Independent School District #146
Buildings and Grounds Committee Meeting
9:00 AM on July 28, 2020
Barnesville High School
302 3rd Street South
Barnesville, MN 56379

FIELD CHANGE ORDER #11

TITLE: *Plumbing Review Revisions*

PROJECT: *Barnesville Public Schools
Additions and Remodeling*

C100

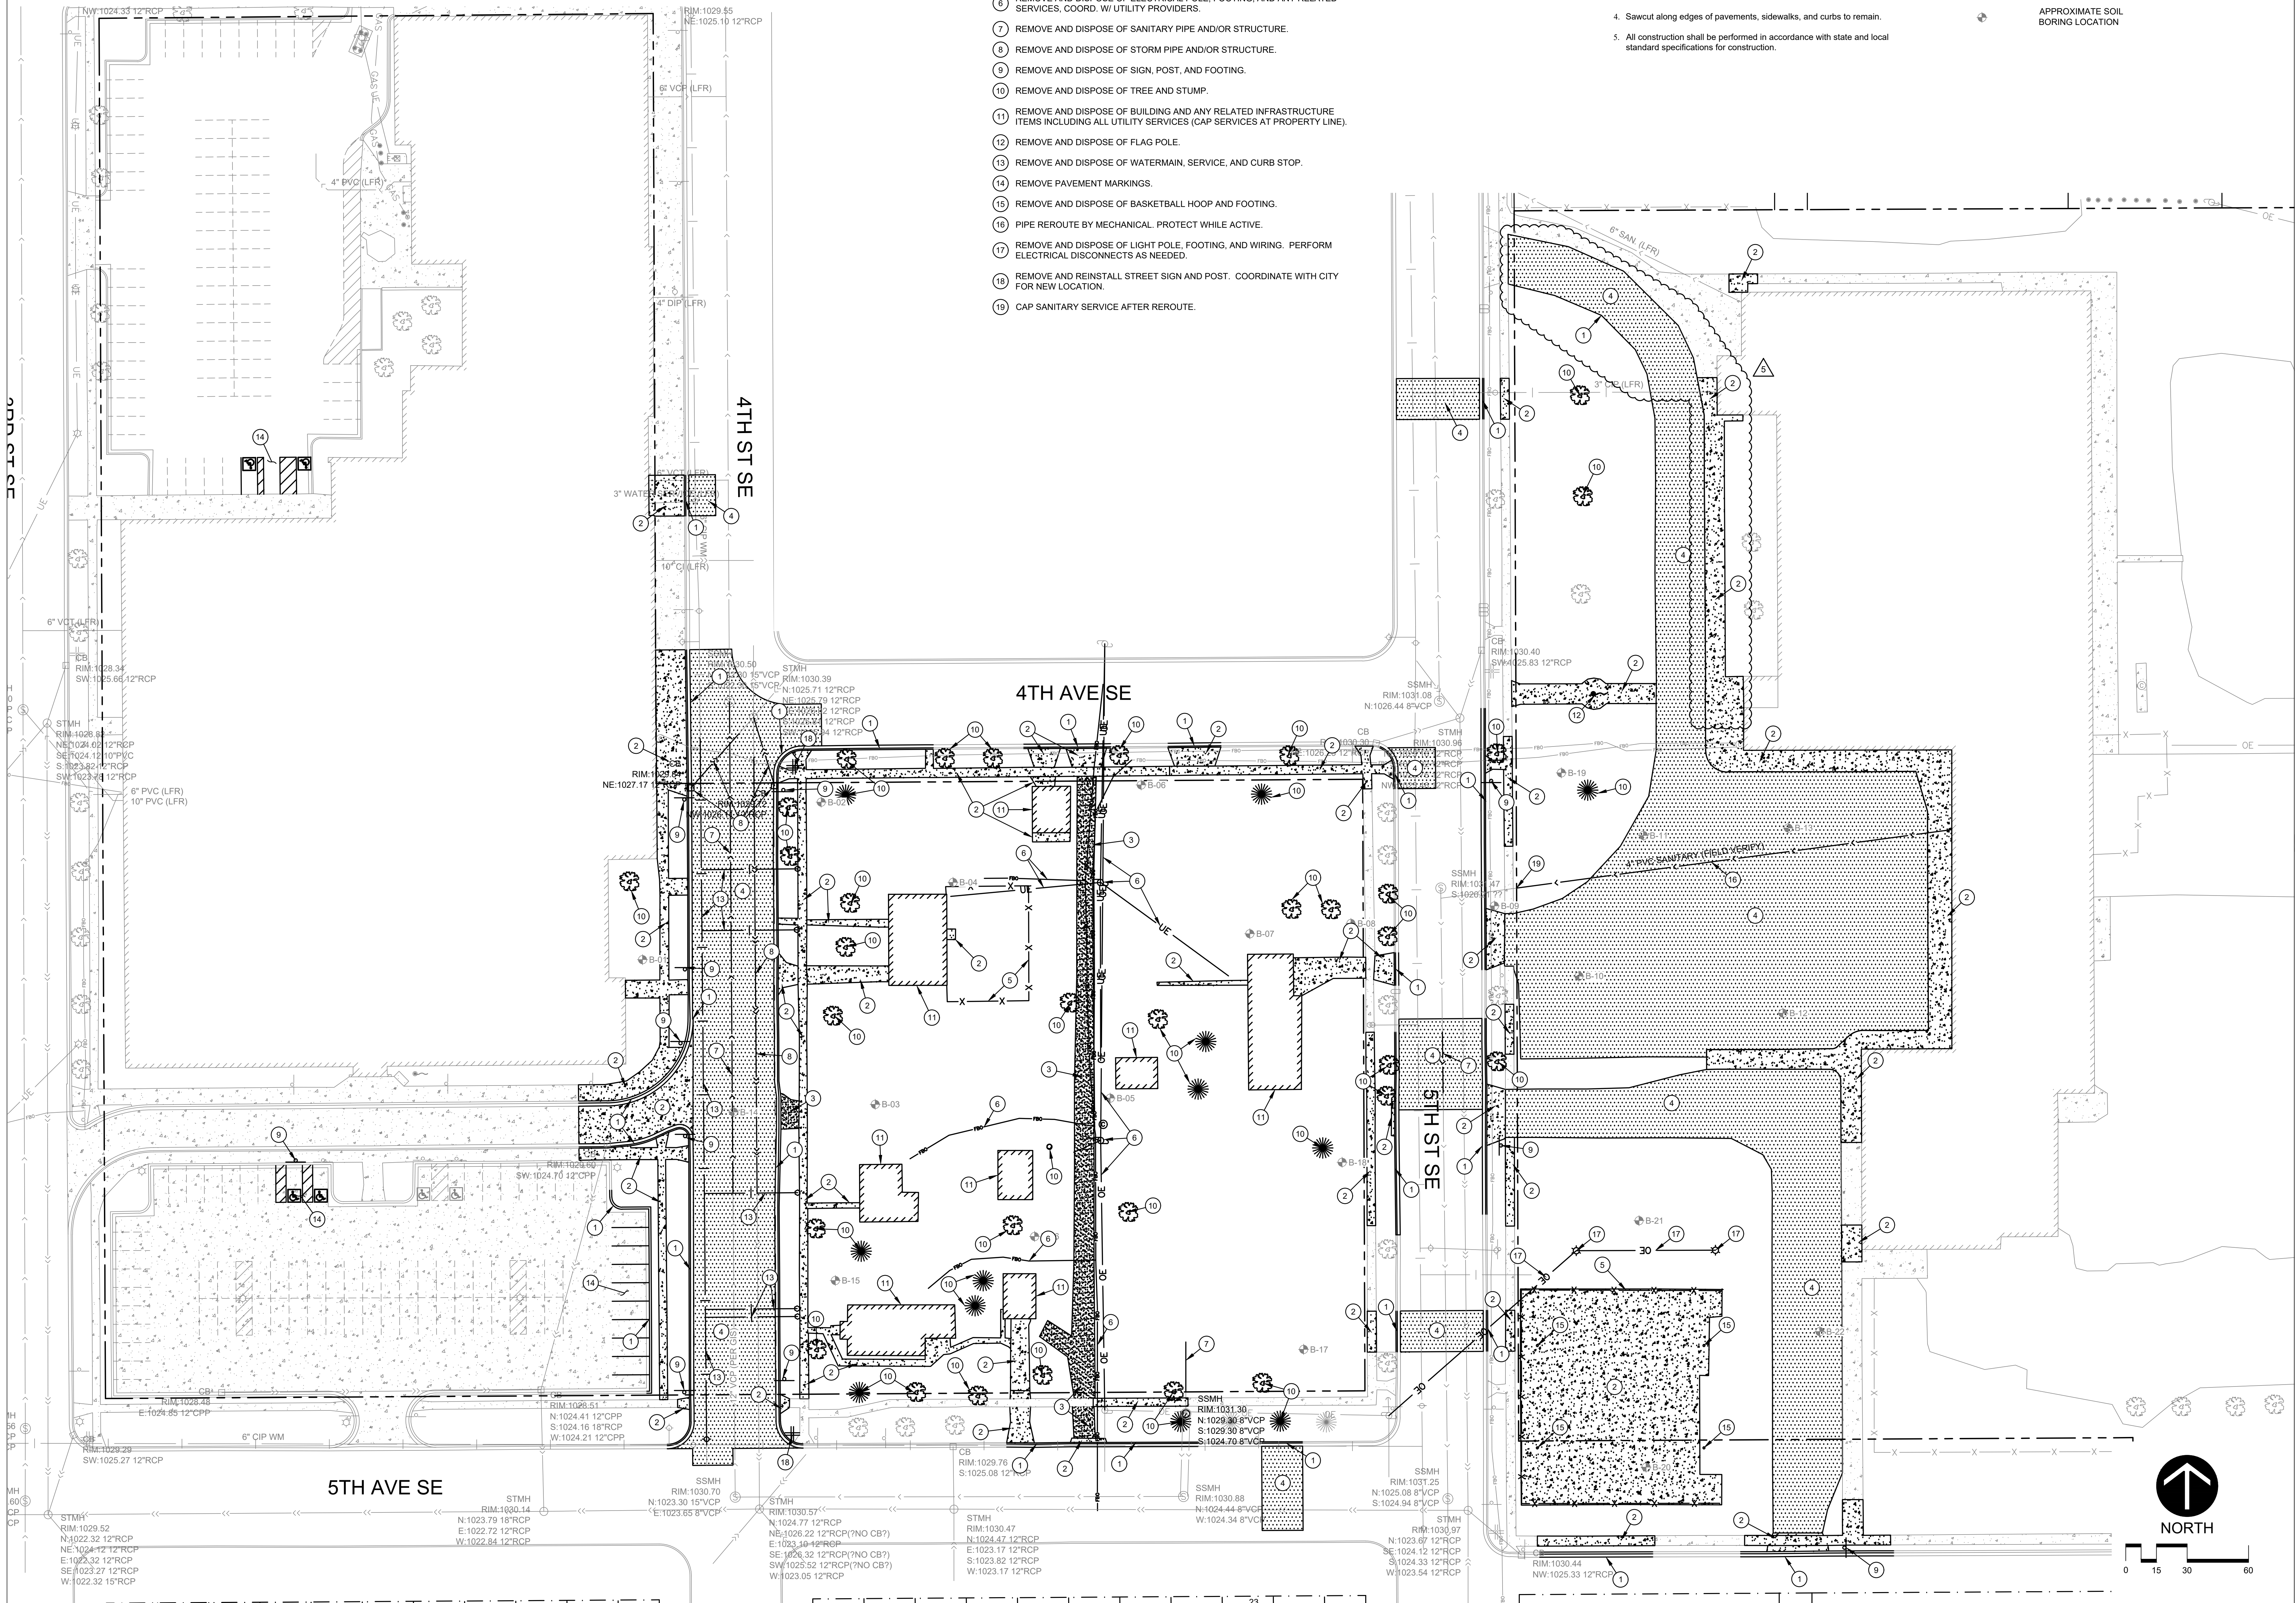
1. Sheet C100 – Demolition Plan (Drawing re-issued)
 - a. Add 258 SY of bituminous pavement removals.
 - b. Add 84 LF of concrete curb removals.
 - c. Add 1,712 SF of concrete removals.
2. Sheet C200 – Paving Plan (drawing re-issued)
 - a. Deduct 419 SY of light-duty bituminous pavement.
 - b. Add 419 SY of heavy-duty bituminous pavement.
 - c. Add 84 LF of B612 Curb and Gutter.
 - d. Add 258 SY of light-duty bituminous pavement.
 - e. Add 1,712 SF of light-duty concrete with integral curb.
3. Sheet C300 – Grading and Erosion Control Plan (drawing re-issued)
 - a. Add/revise grades around revised concrete and bituminous areas.

MD-1202

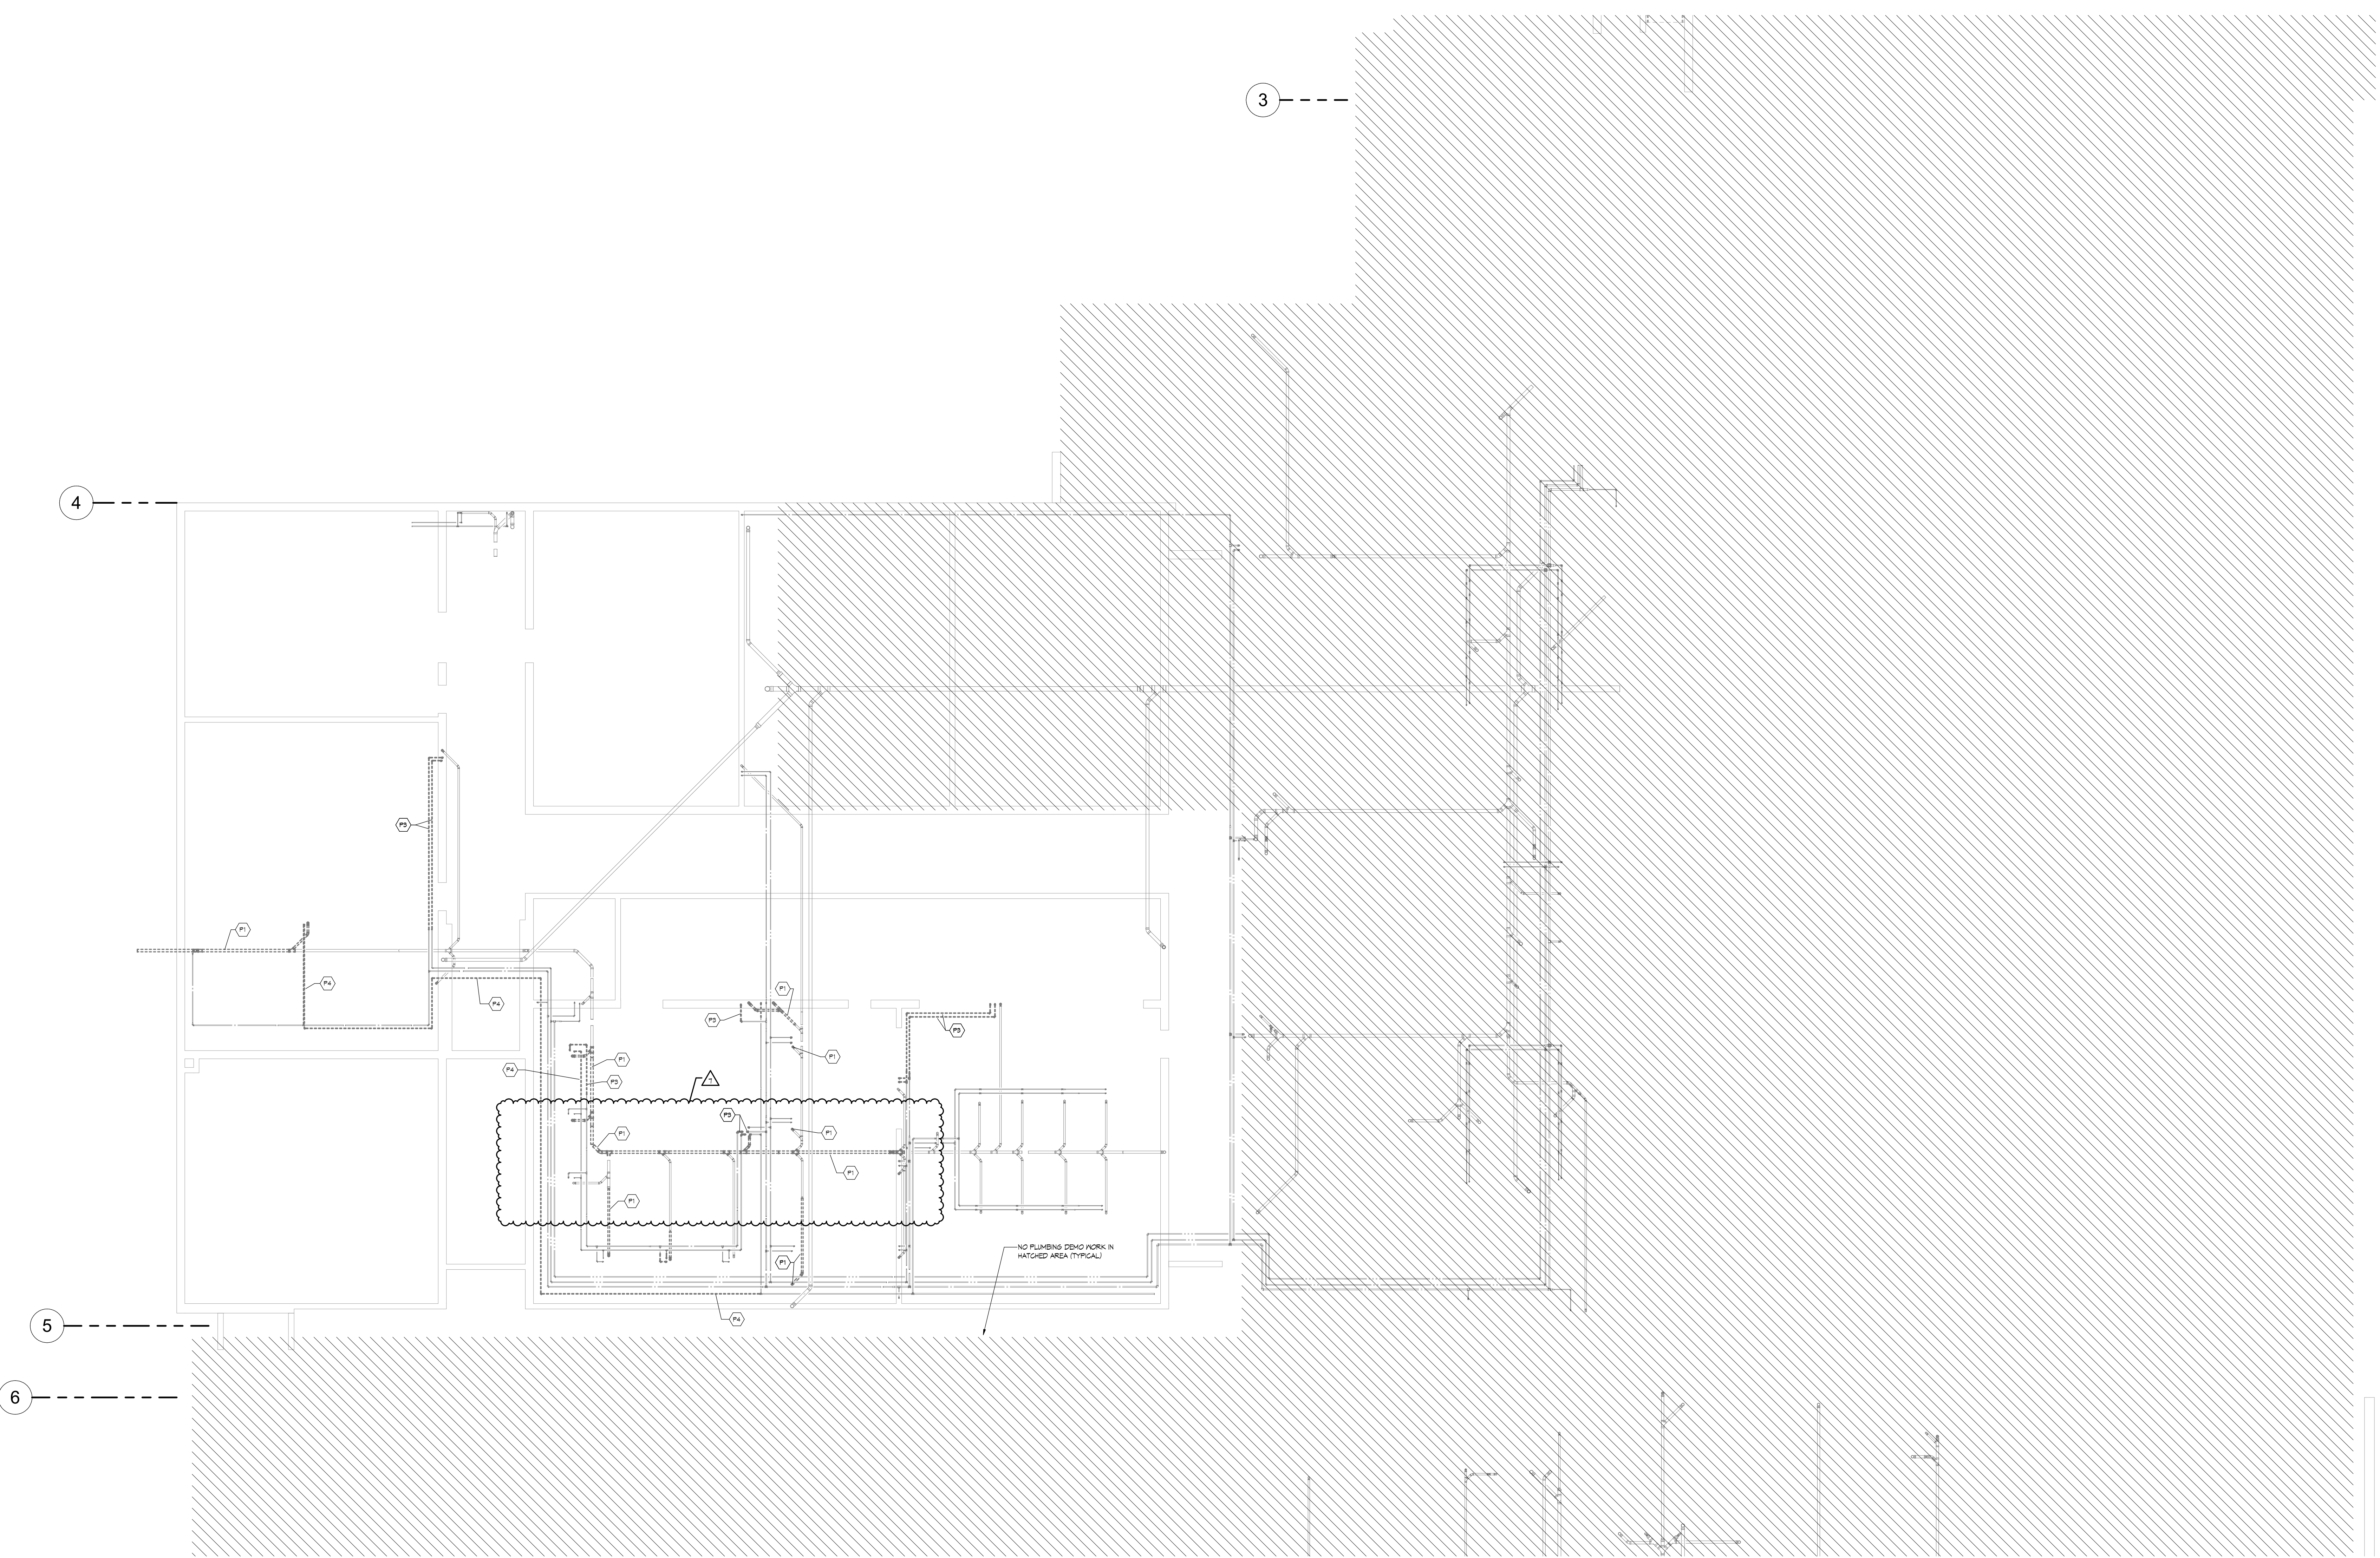
Based on field conditions, the waste line in the chemistry room is to be demo'd and replaced with new up to the point indicated. If, it is needed to be extended into the Biology room for those sinks to hit the invert, that work shall be done on a time and material basis (just extending the main, the routing/floor cutting of the sinks should have been picked up in previous PR for plan review).
